ENVIRONMENTAL REVIEW TEAM REPORT
ON
ARROWHEAD RIDGE
COVENTRY, CONNECTICUT
NOVEMBER, 1975

Project CPA-CT-01-00-1037

ENVIRONMENTAL REVIEW TEAM REPORT
ON
ARROWHEAD RIDGE
COVENTRY, CONNECTICUT

TOPOGRAPHY

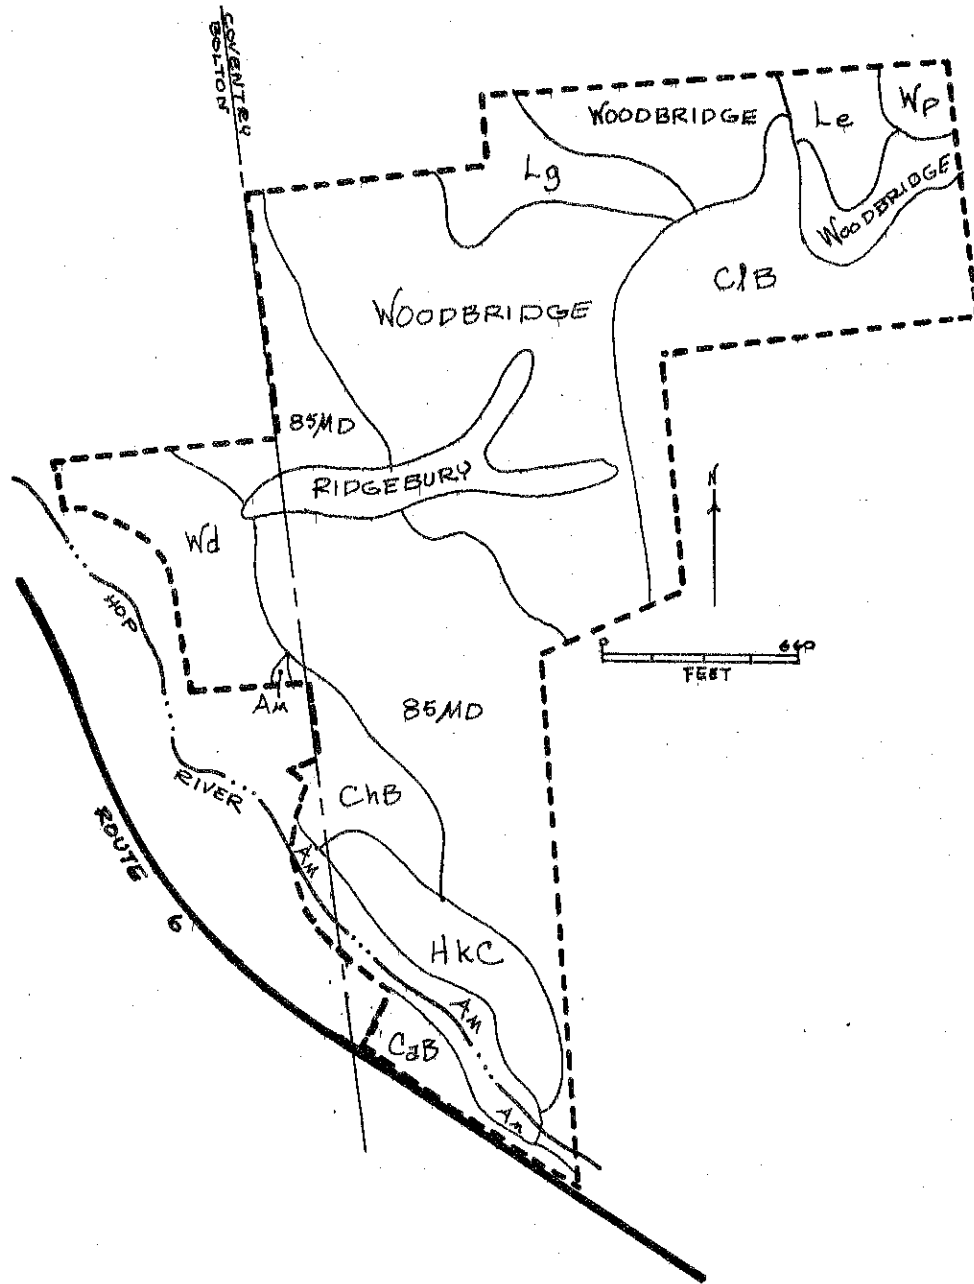
The topography map illustration indicates the approximate area of the site which falls within the 15% or greater slope regime. The development plans for Arrowhead Ridge indicate that the leaching field galleries are proposed for the same approximate area.
